16" CUP WITH 10" OVERALL HEIGHT

DRAWING NUMBER
TMSCUP16914 REV B

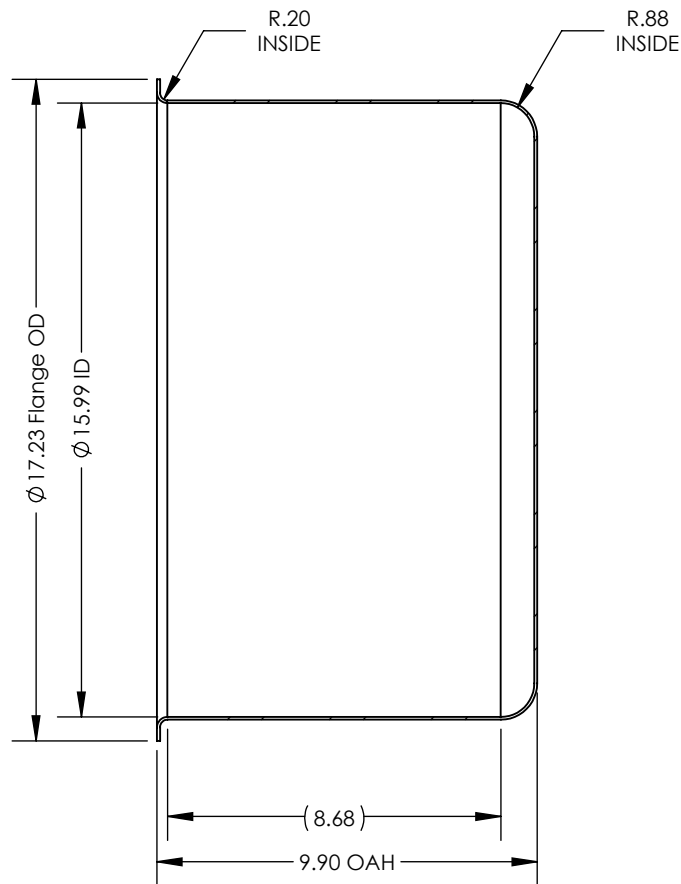
| A | Updated sheet format, corrected title block and revision block author information, changed Flange OD from 17.26" to 17.18", changed ID from 16.08" to 15.99", changed Flange Radius from 0.22" to 0.20", added Straight Wall ref dimension. | 17JAN2019 | R.DAVIS |
| B | Changed Flange OD from 17.18" to 17.23", changed OAH from 10.08" to 9.90" | MAR2019 | R.DAVIS |
